EOC-Providence VAMC Fire and Fire/Smoke Damper Failed Report

EOC-PROVIDENCE VAMC FIRE AND FIRE/SMOKE DAMPER FAILED REPORT

03/04/15

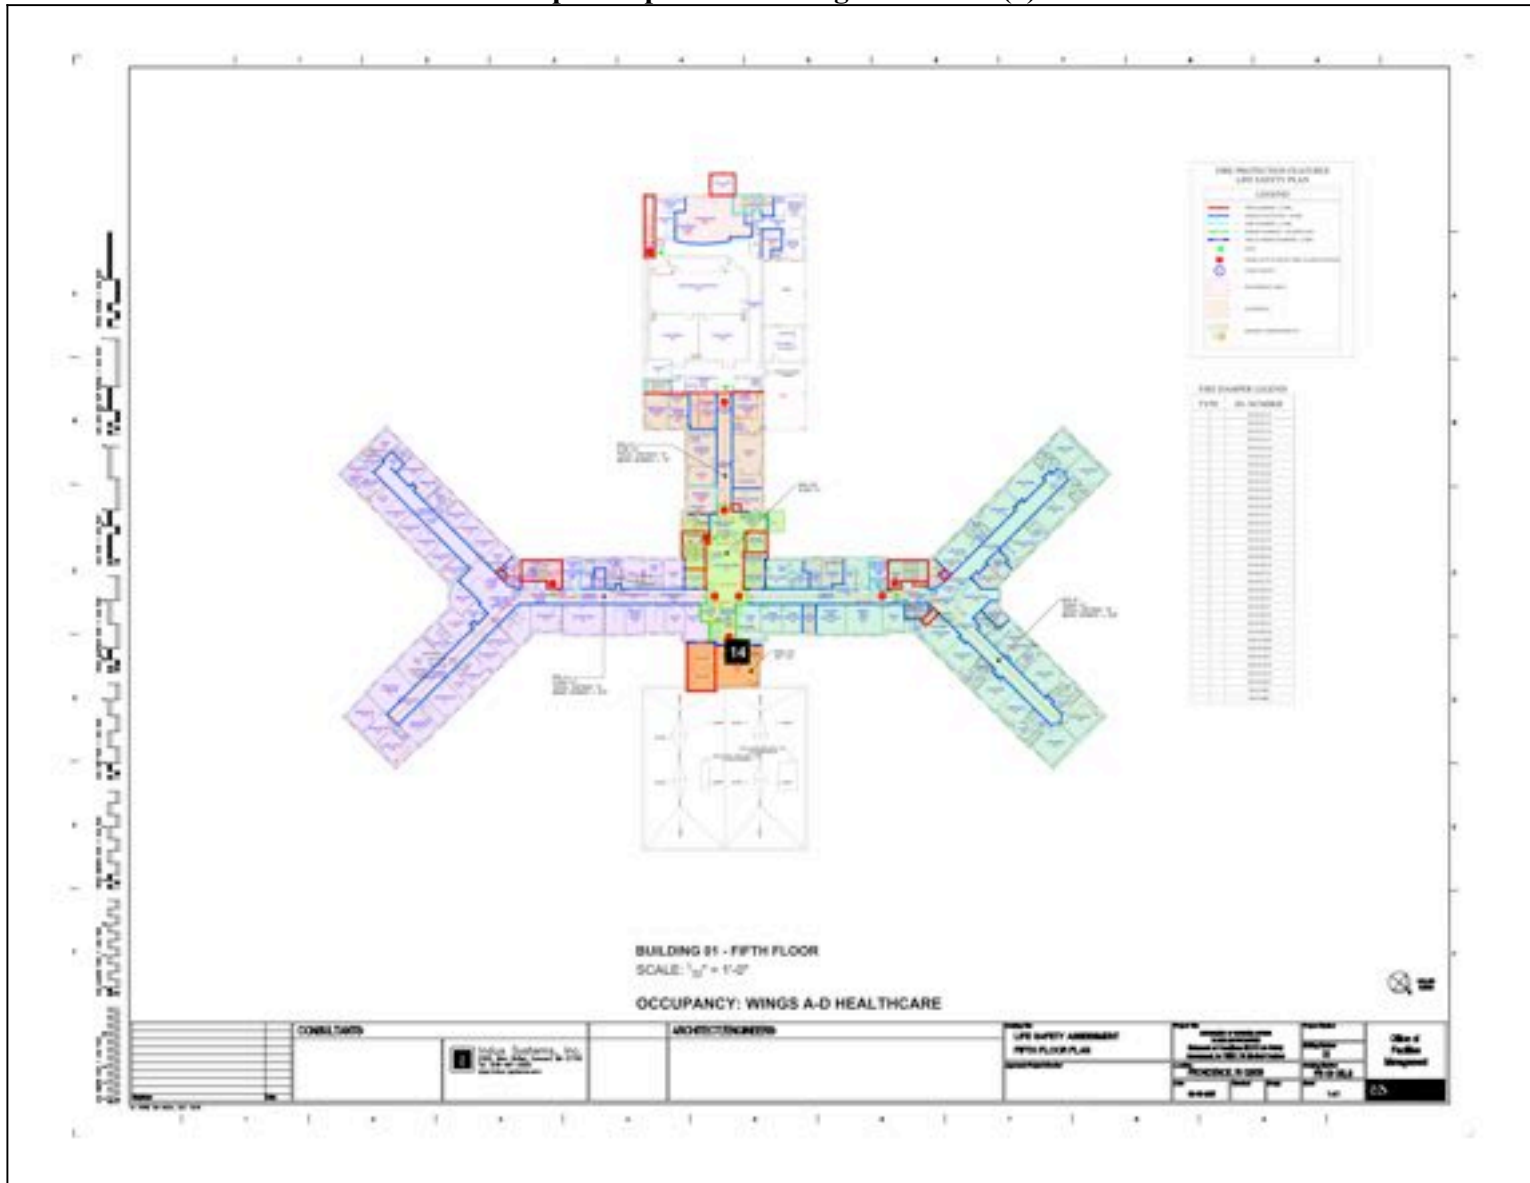
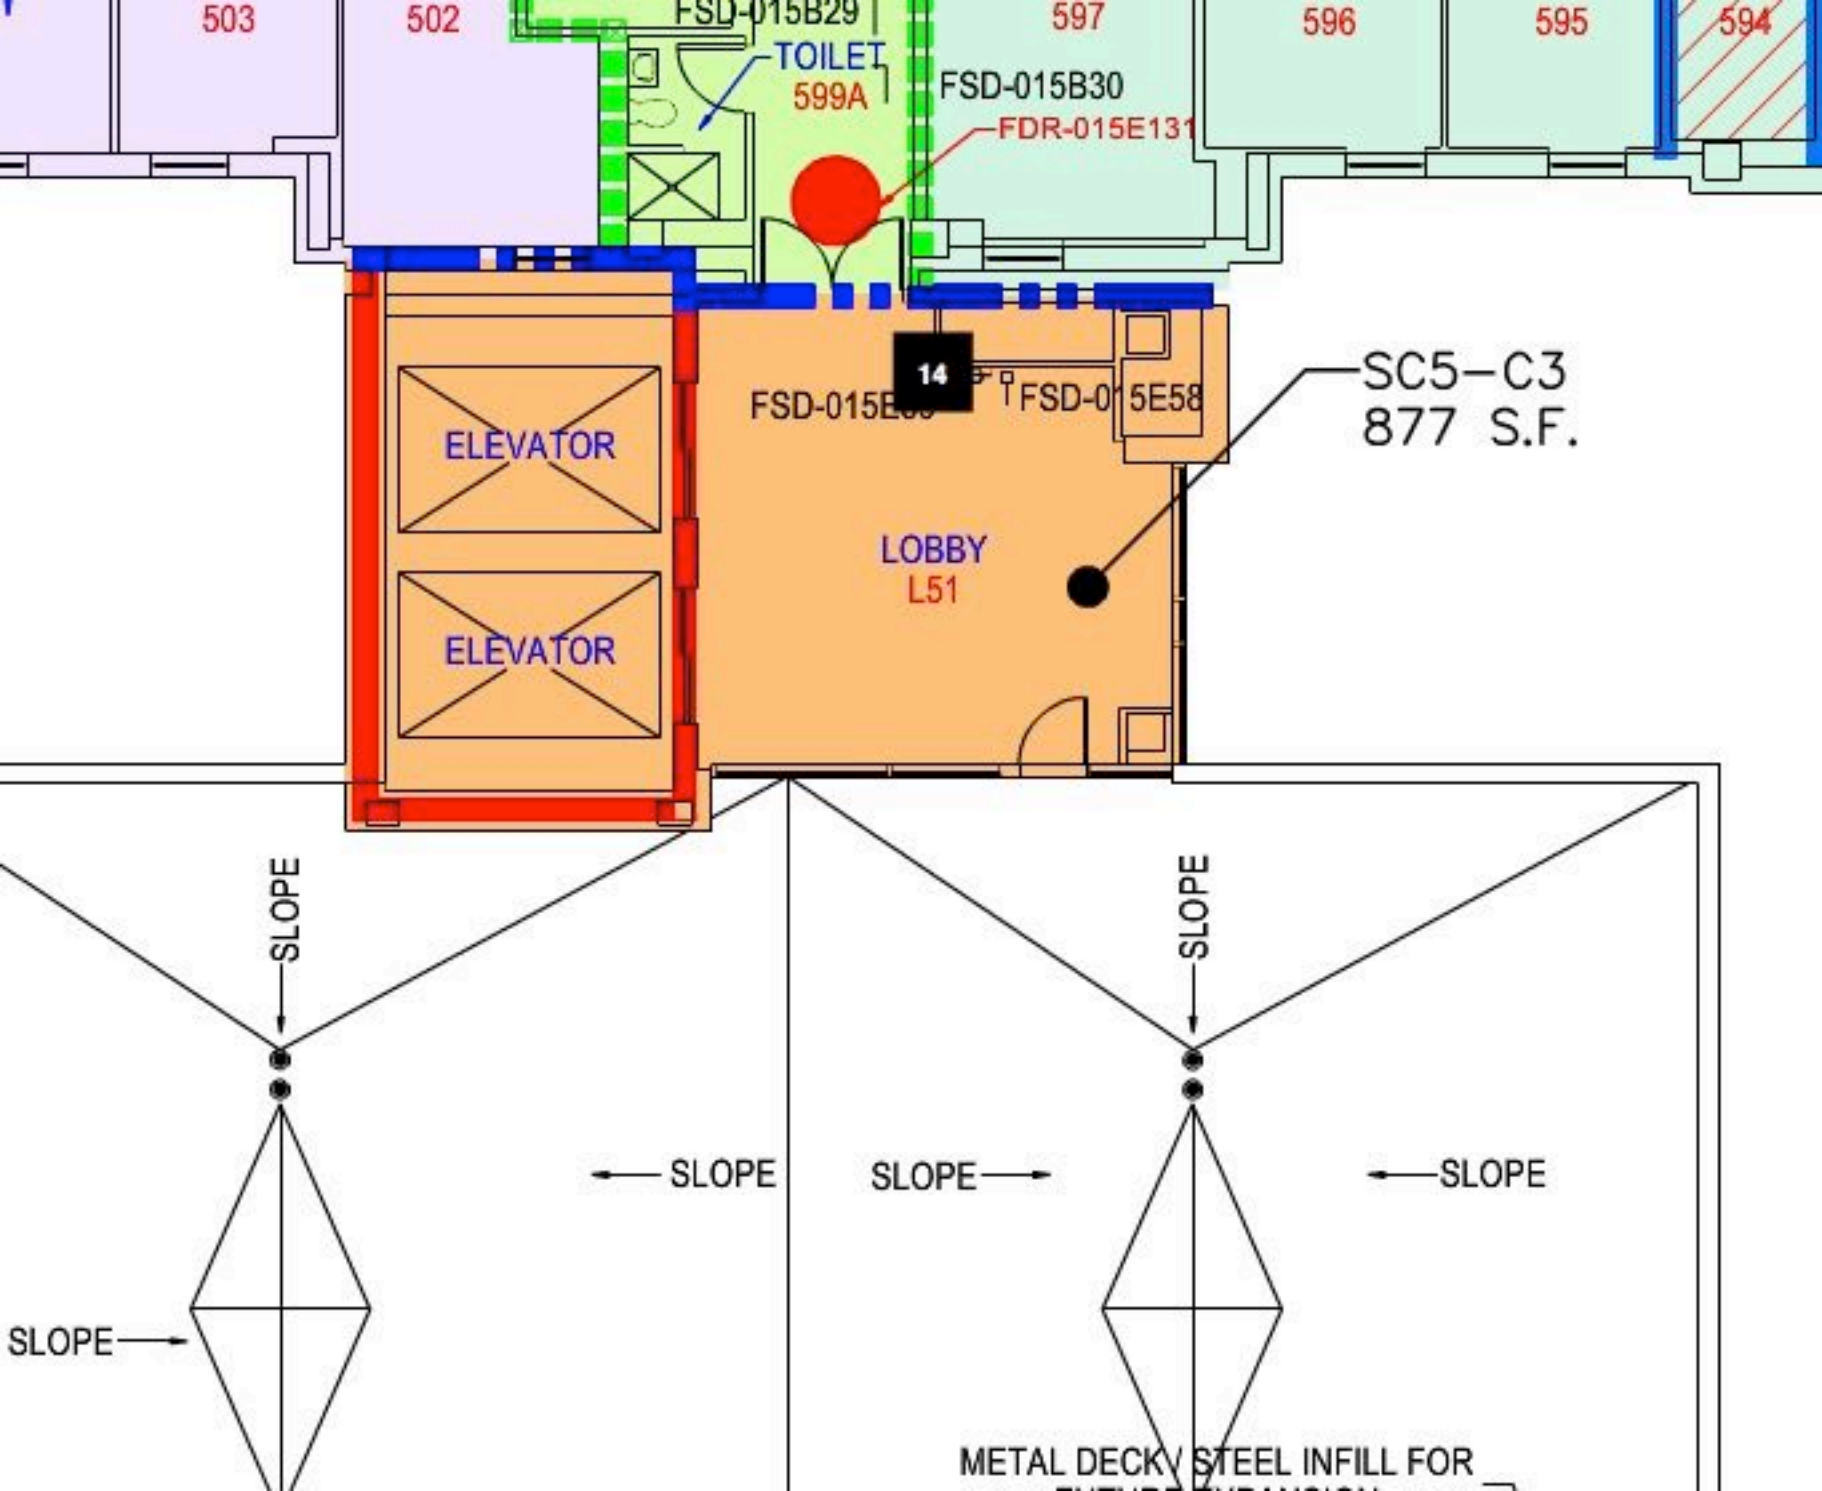
Date Created	Damper Asset Tag #	Damper Size	EOC ID #	Punch #	Type	Floor	Comments
1/13/15	FD-014E171	8x6	211832	7	Fire Damper	4th Floor	Damper Failed. Damper was damaged during installation and was not installed in the plane of the barrier. Reference: NFPA 80 2013 Section 19.2.1.1.1 A damper installed in a fire resistance-rated assembly shall be located (in its sleeve) within the plane of the fire resistance-rated assembly, unless listed otherwise and installed in accordance with the manufacturer's installation instructions and the listing.

Damper Inspection E-Wing / 5th Floor (5) -

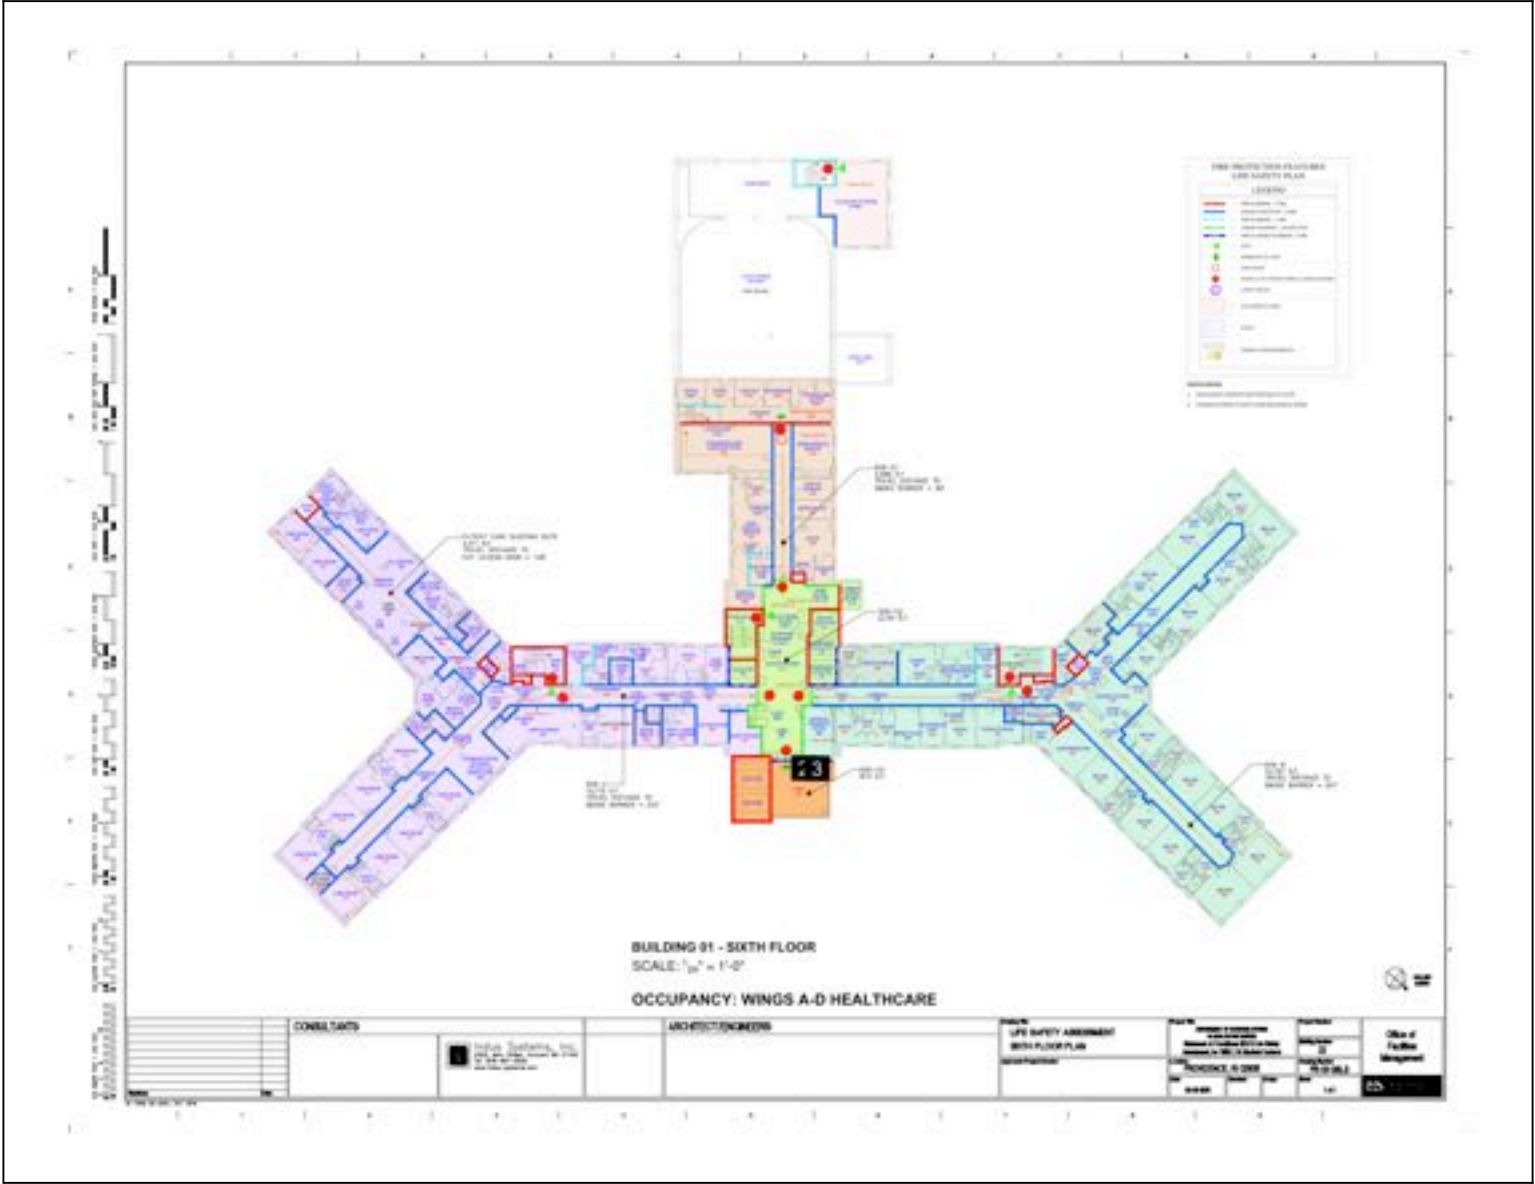
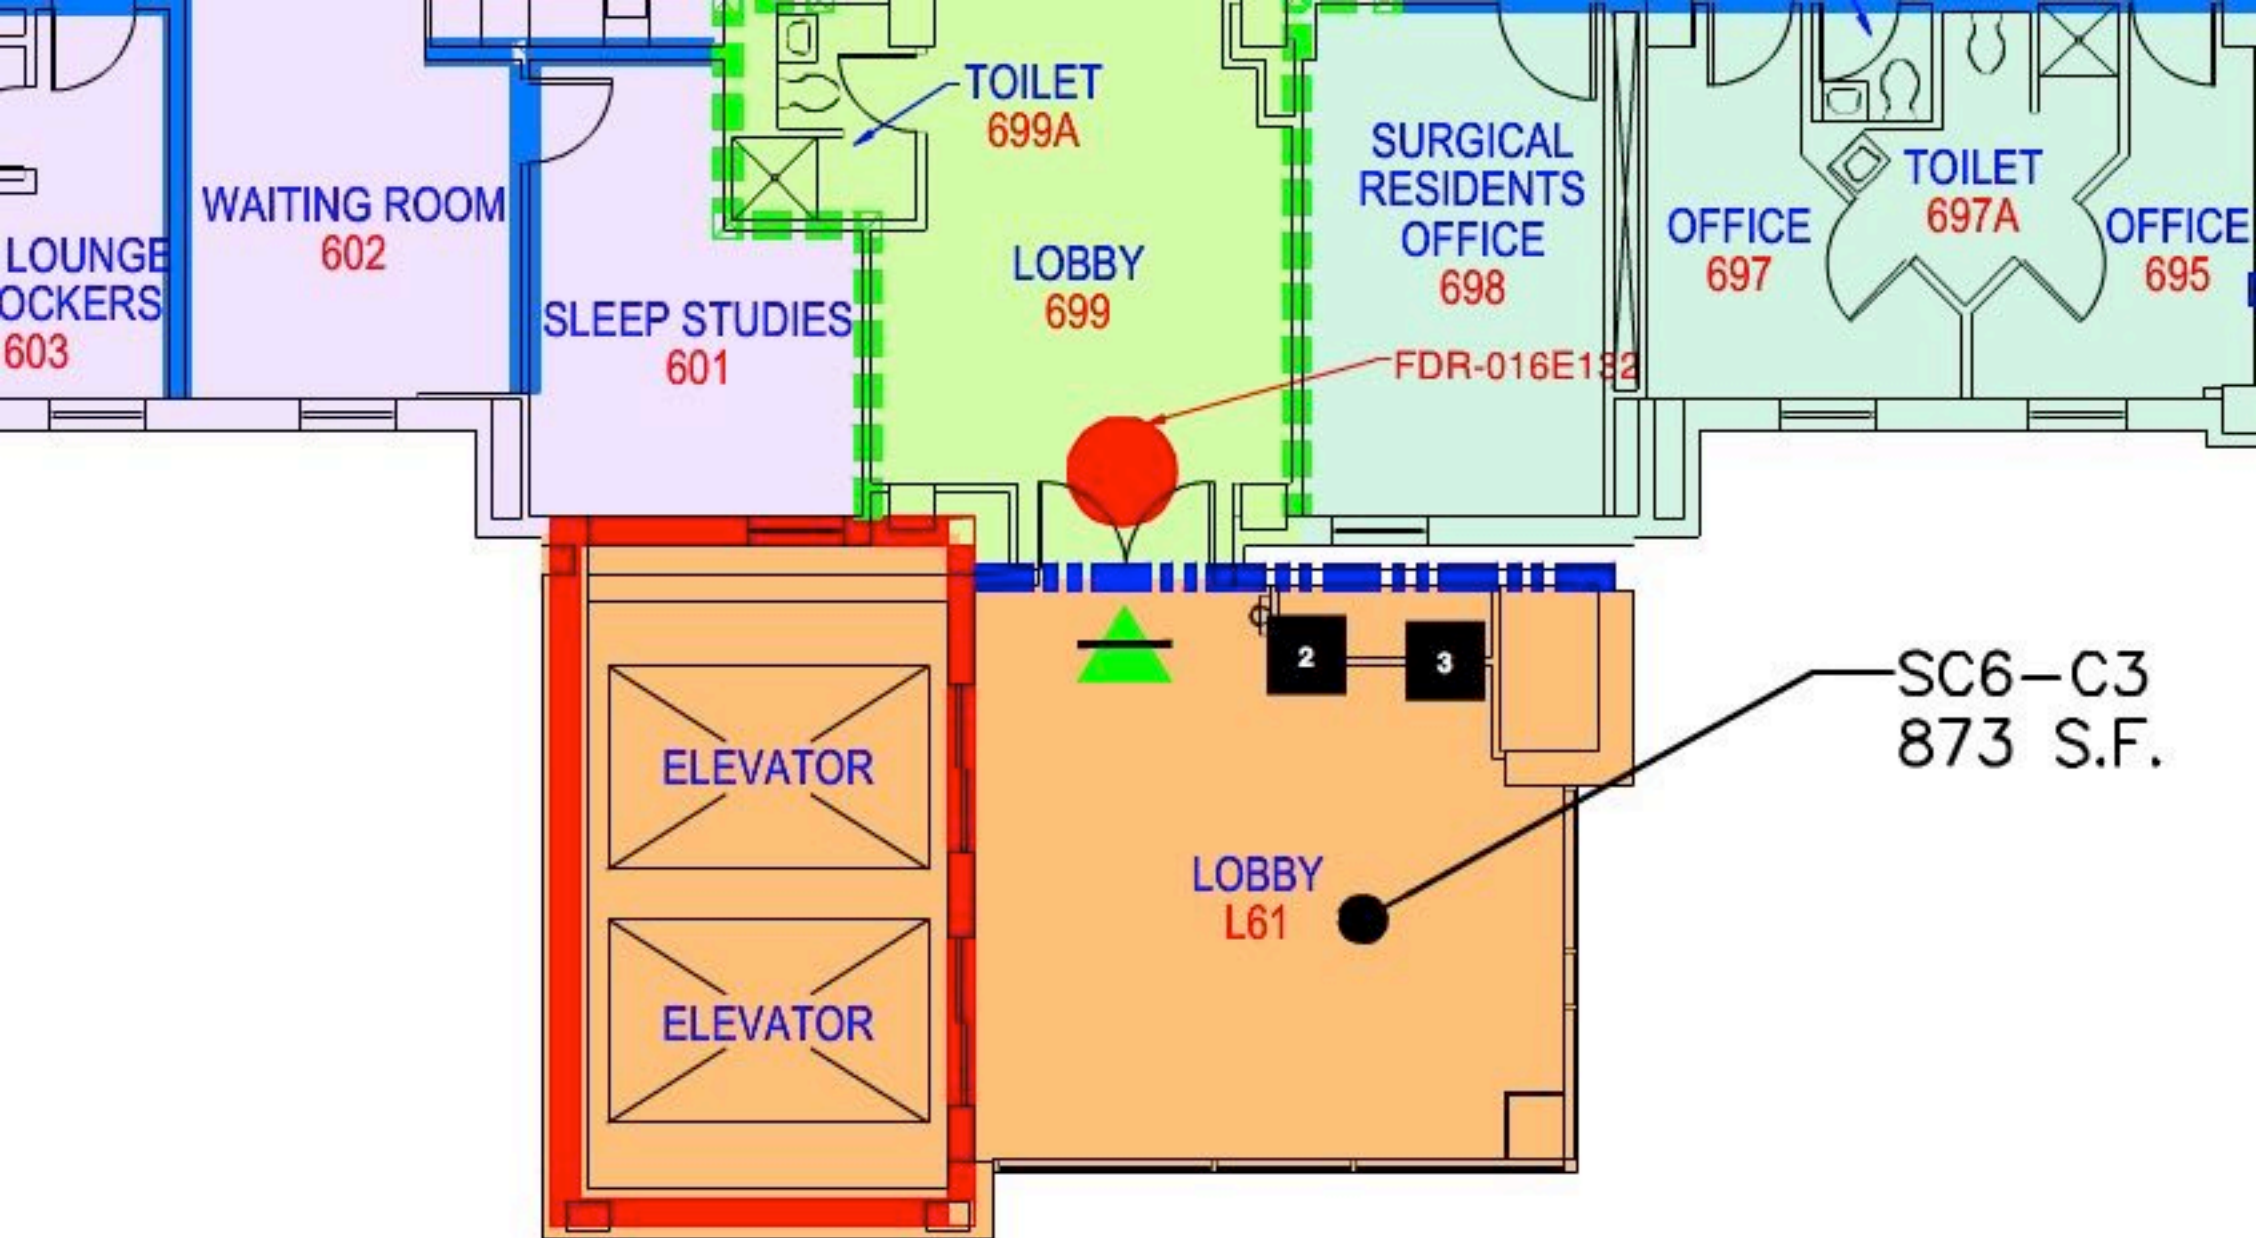
Date Created	Damper Asset Tag #	Damper Size	EOC ID #	Punch #	Type	Floor	Comments
1/13/15	FSD-015E59	14x12	211834	14	Smoke/Fire damper	5th Floor	Damper Failed. No visible access. Actuator appears to be functioning properly, air flow stops which indicates that the damper is closing, but no visible access. Access door needs to be moved to gain visible access.
 <p>1/13/15 07:40 AM</p>
